Ref: 0417r02v02

**RE: 227 BUNGARRIBEE ROAD, BLACKTOWN (DA-21-00559)
KRISHATHI PTY LIMITED -V- BLACKTOWN CITY COUNCIL (LEC CASE NO. 2021 / 146822)
LETTER OF RESPONSE TO TRAFFIC CONTENTIONS**

We refer to recent correspondence concerning the abovementioned Court proceedings and the Statement of Facts and Contentions (SOFC) issued by Blacktown City Council (Council) dated 14/07/2021, relating to the deemed refusal of Development Application, DA-21-00559.

Ground Level Plan

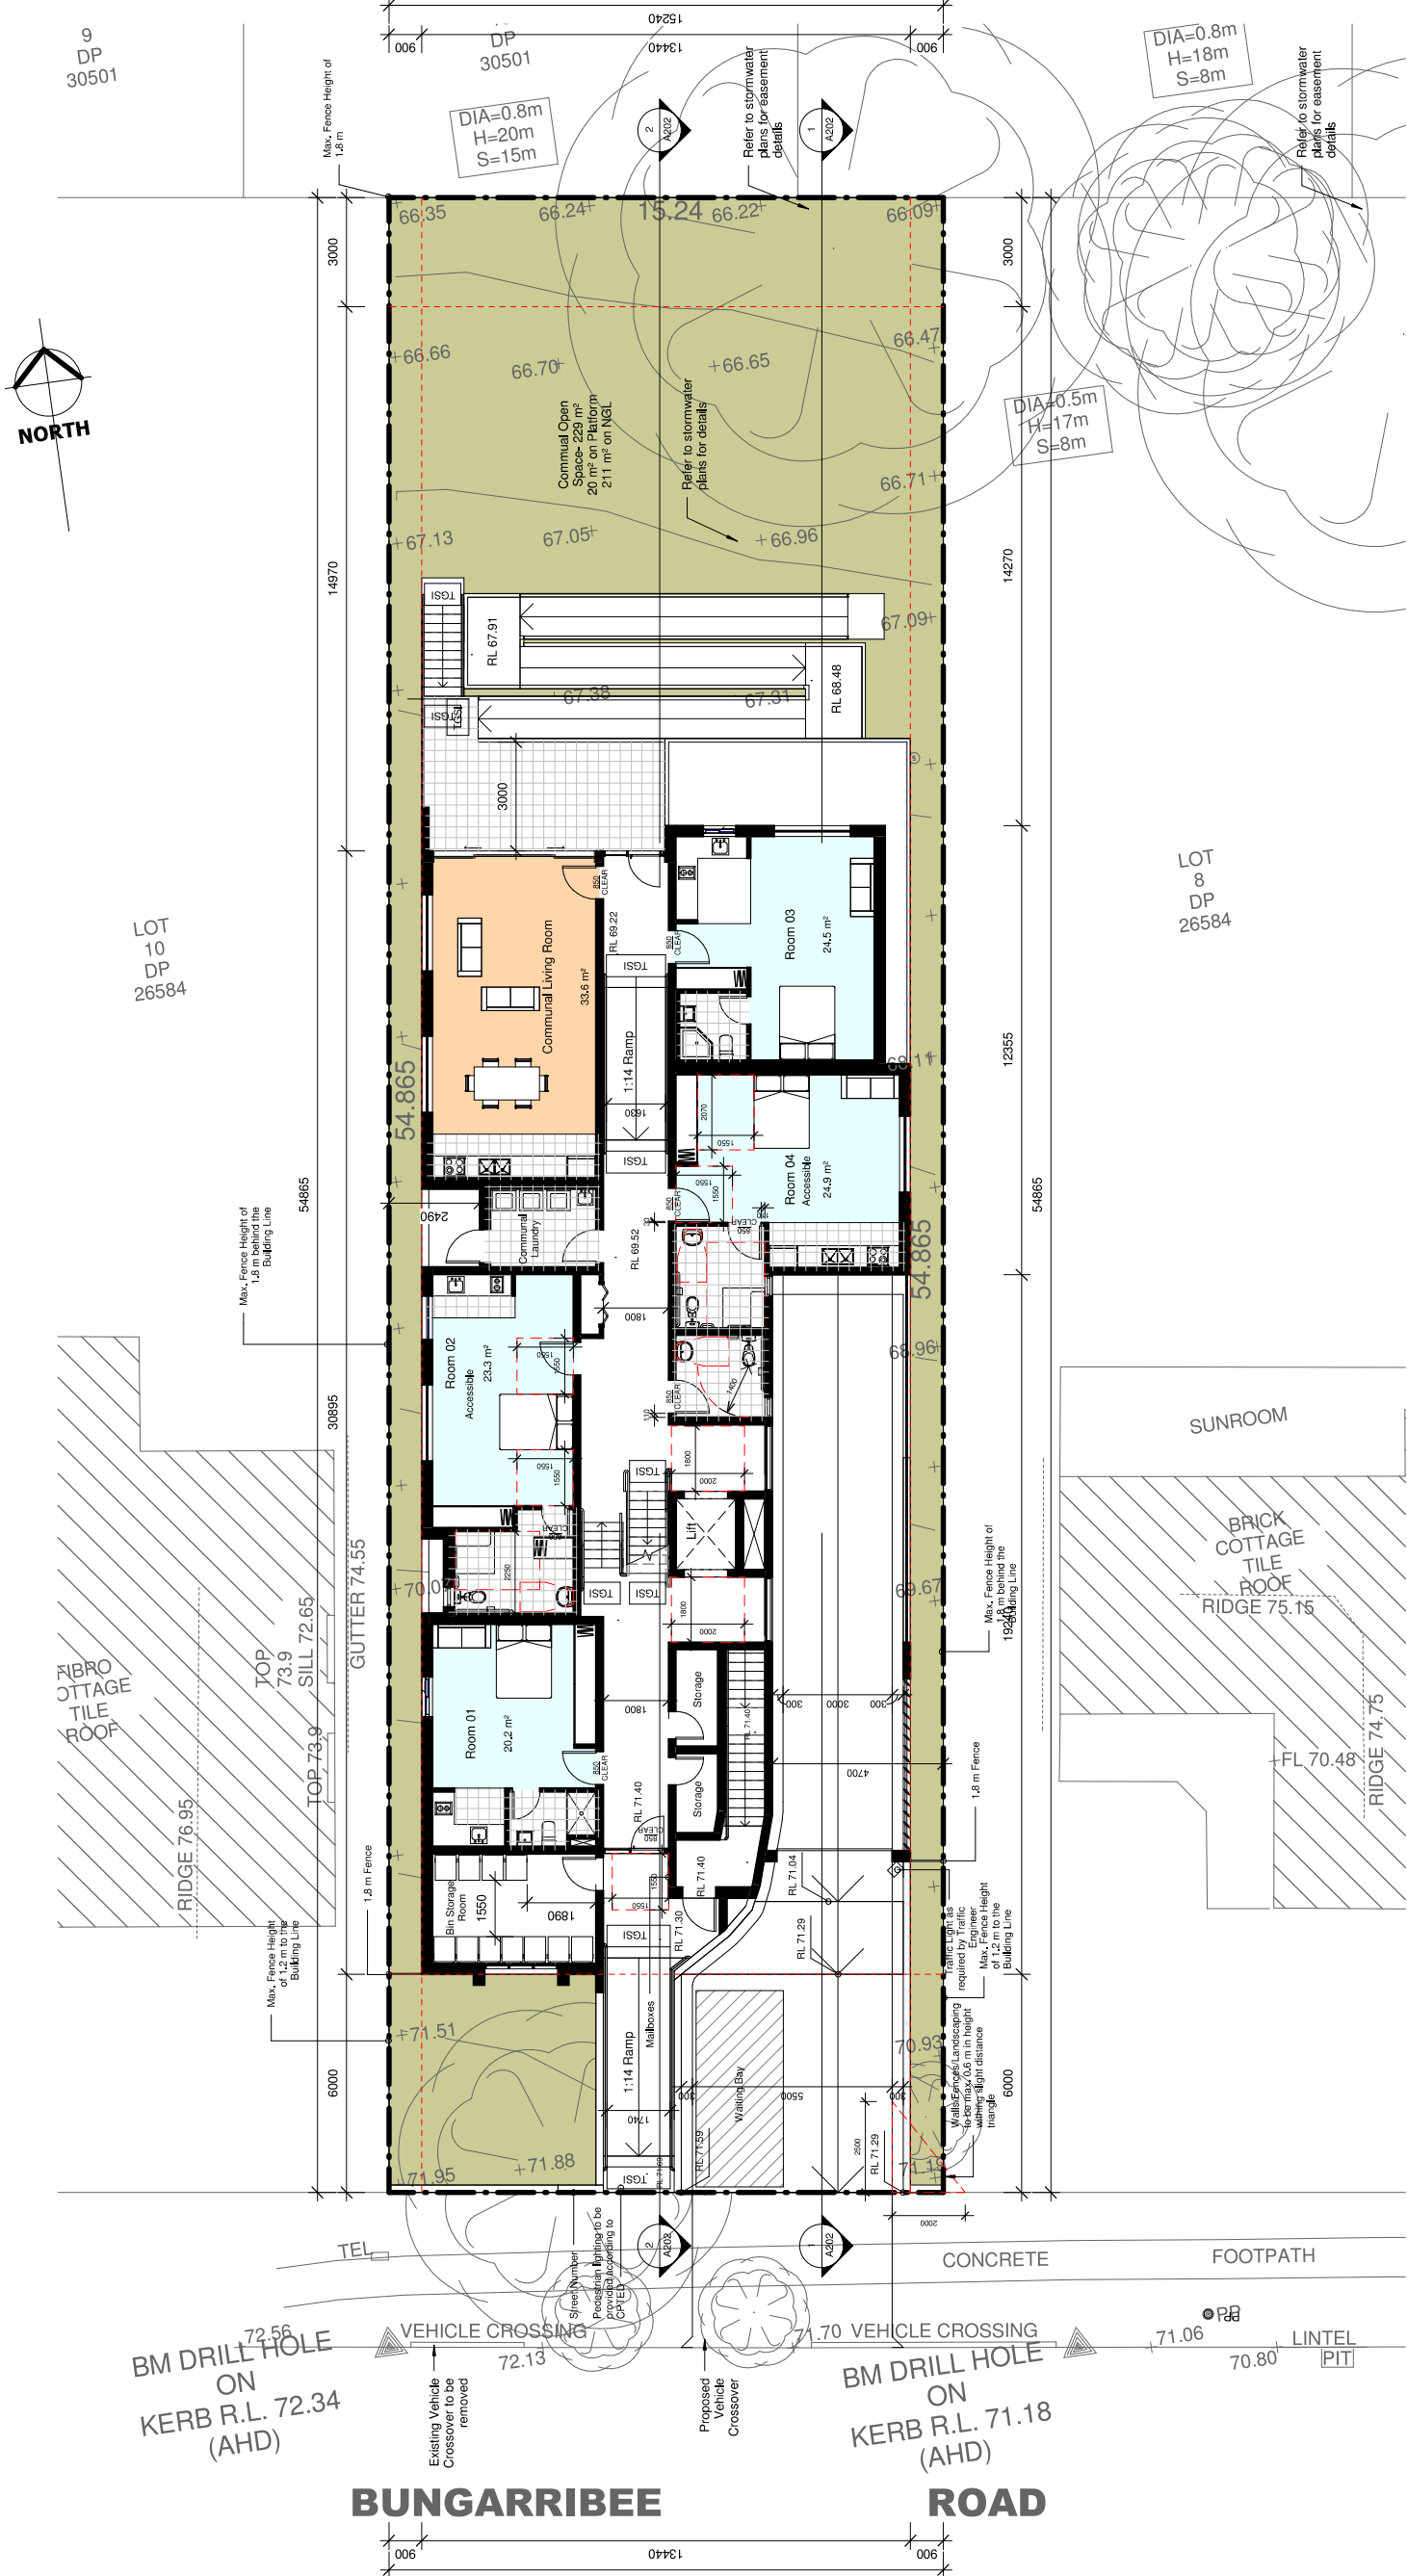
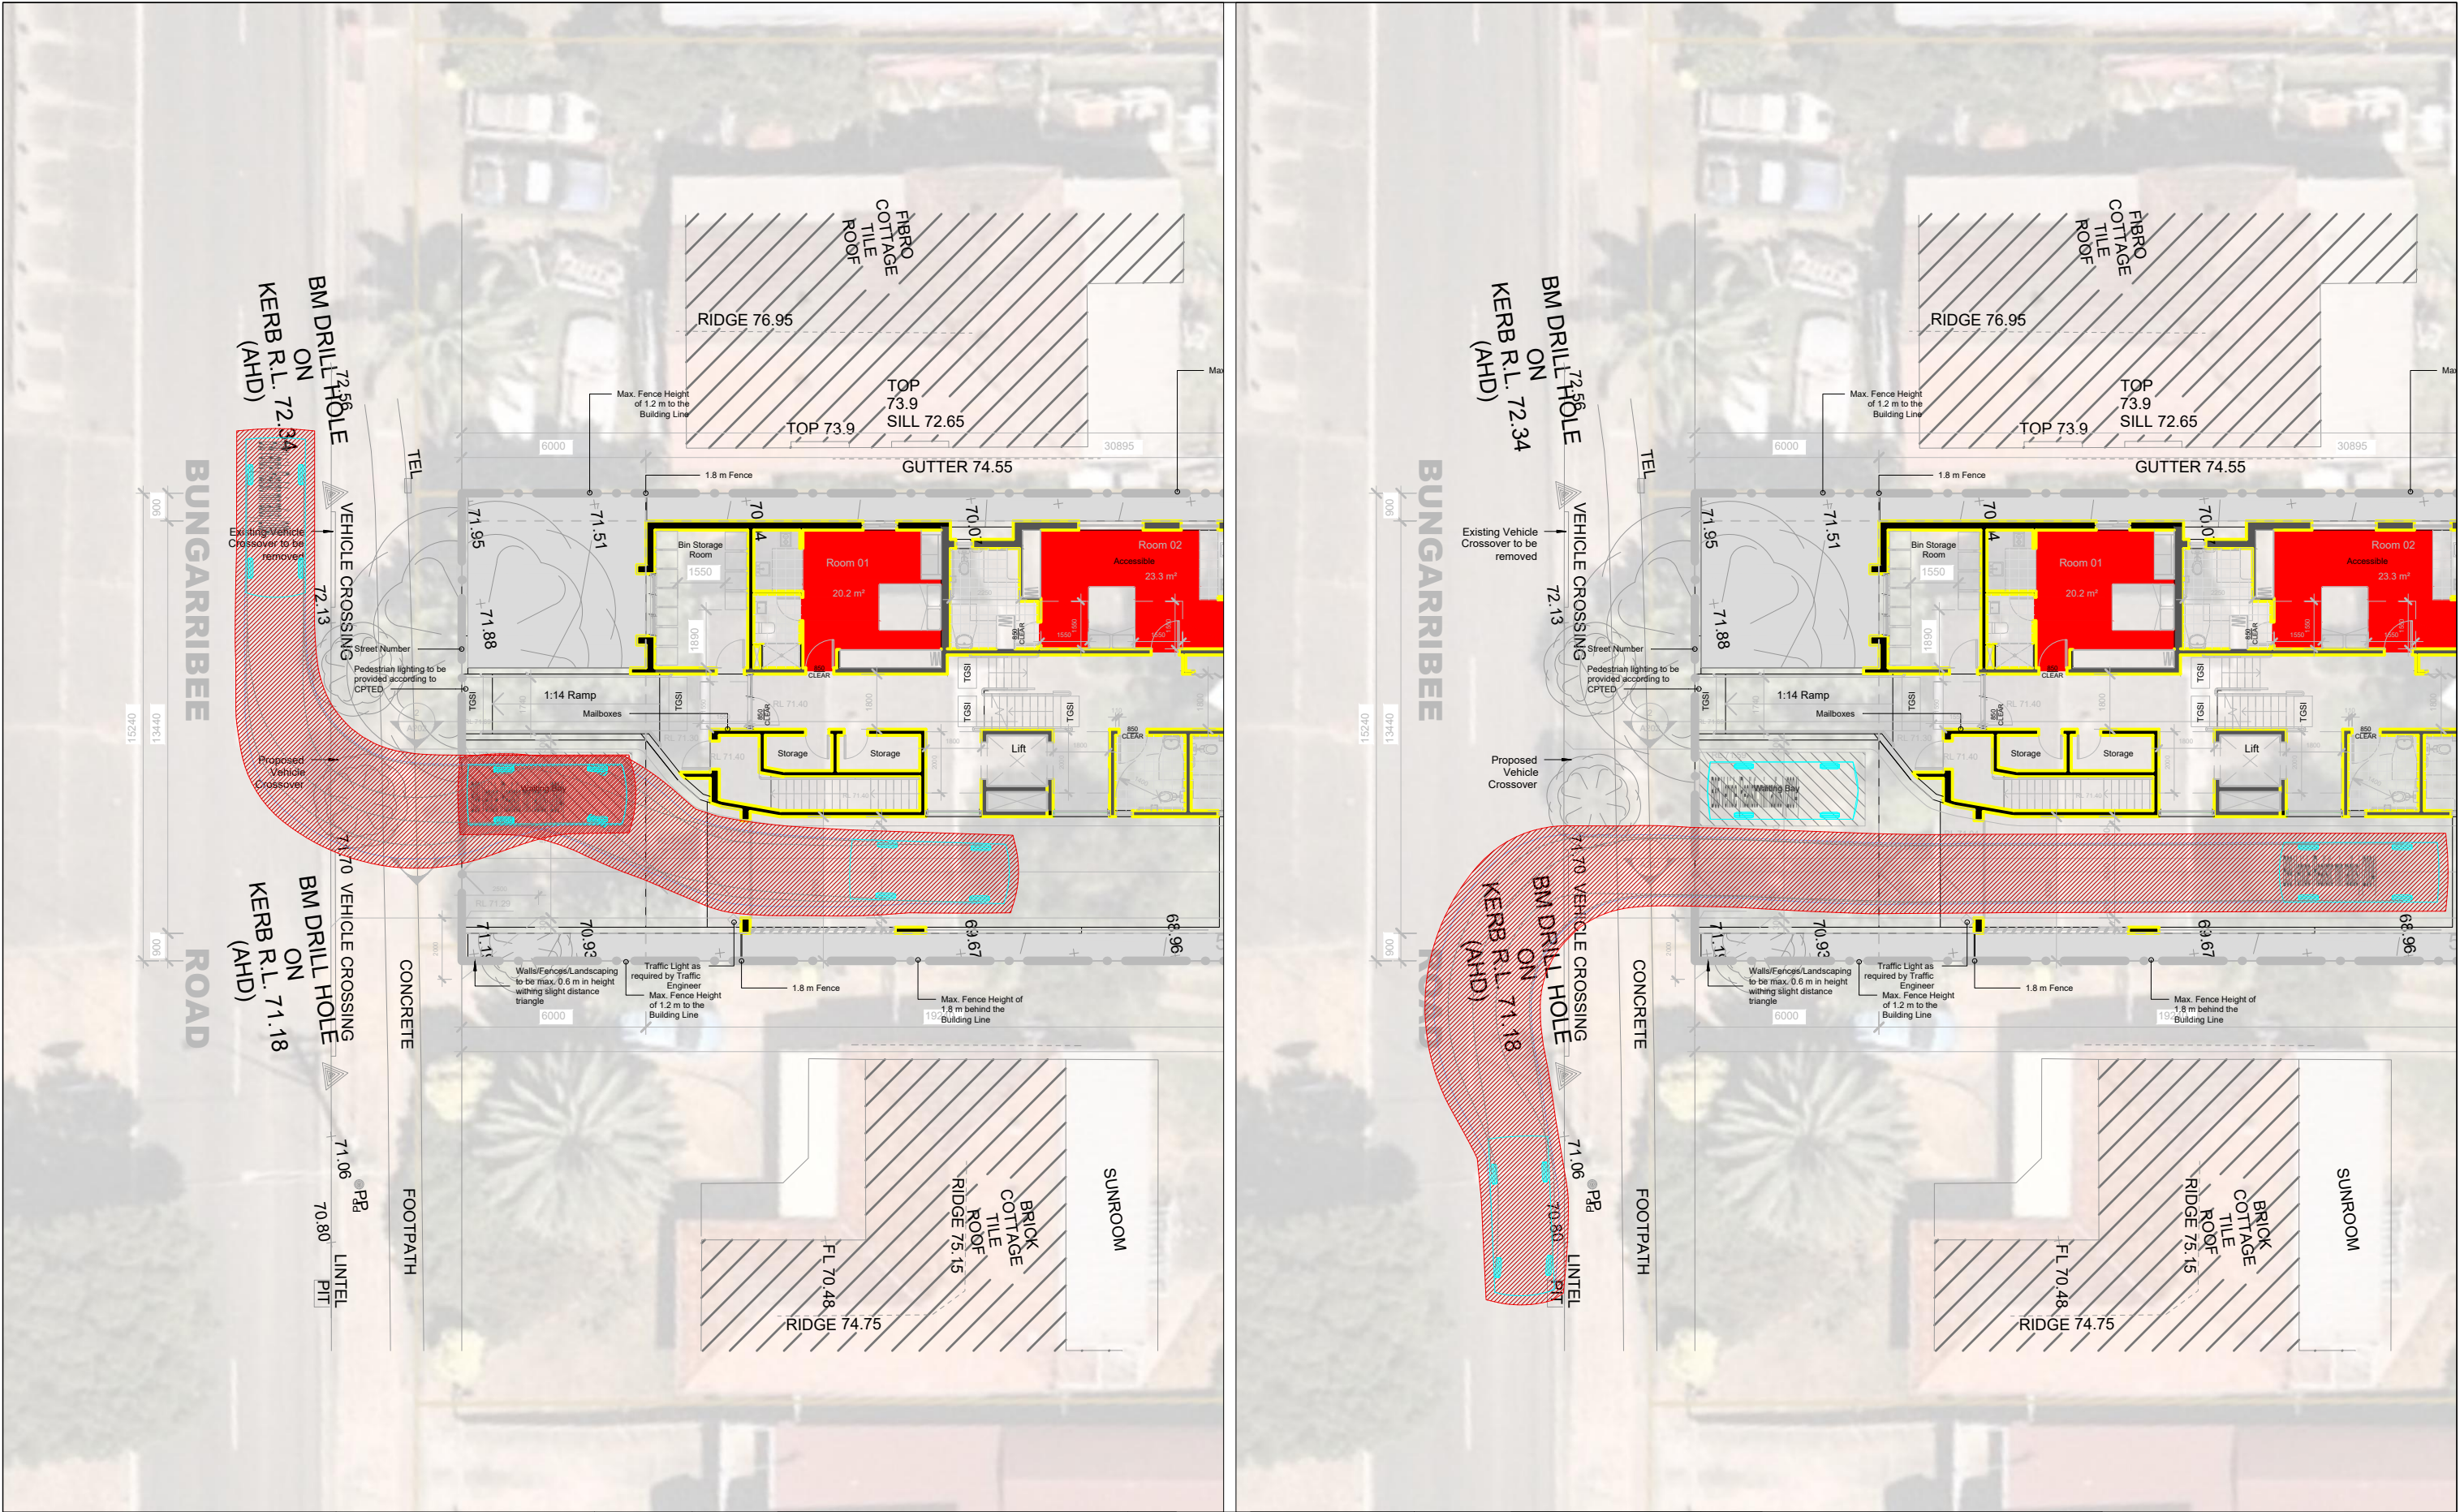
a) Sufficient provision for adequate sight distance needs to be made for both pedestrian and vehicular movement in accordance with Section 3.2.4 AS 2890.1, Figure 3.2 of AS2890.1 and Figure 3.3 of AS2890.1 to ensure safety of pedestrians on the footpath system and motor vehicles along the new driveway.

c) There are no mitigation measures proposed to manage two-way passing along the single width ramp and within the basement car park. Vehicles entering the site will be unable to see a vehicle leaving the Site and will not know to enter the passing bay upon entry. This will result in reverse movements back out onto Bungarribee Road, contrary to the design requirements within AS2890.1. Any proposed mitigation measures to manage two-way passing conflicts will need to be assessed to ensure vehicle queuing does not occur on the public road or verge.

The amended drawings included in **Attachment 1** demonstrate the development will provide a compliant 2.5 metre x 2.0 metre visual splay on the egress side of the driveway in accordance with Figure 3.3 of AS 2890.1. The existing fence along the eastern boundary will be demolished and replaced with a new fence having a maximum height of 600 mm ensuring that compliant sight distances are achieved between exiting motorists and any pedestrians that may be walking along the northern footpath of Bungarribee Road.

The amended drawings included in **Attachment 1** indicate that a traffic signal system will be provided to manage two-way traffic flow along the one-lane ramp. The traffic signal system will ensure that only one vehicle travels along the ramp at any one time and result in a safe design outcome.

Nevertheless, we note that the amended drawings included in **Attachment 1**, demonstrate that the 7.7 metre aisle width within the basement substantially exceeds the minimum 5.8 metre aisle width required under AS 2890.1. The increased aisle width, in combination with the compliant car parking layout, provides ample space for vehicle manoeuvring as demonstrated by the updated swept path results included in **Attachment 2**.
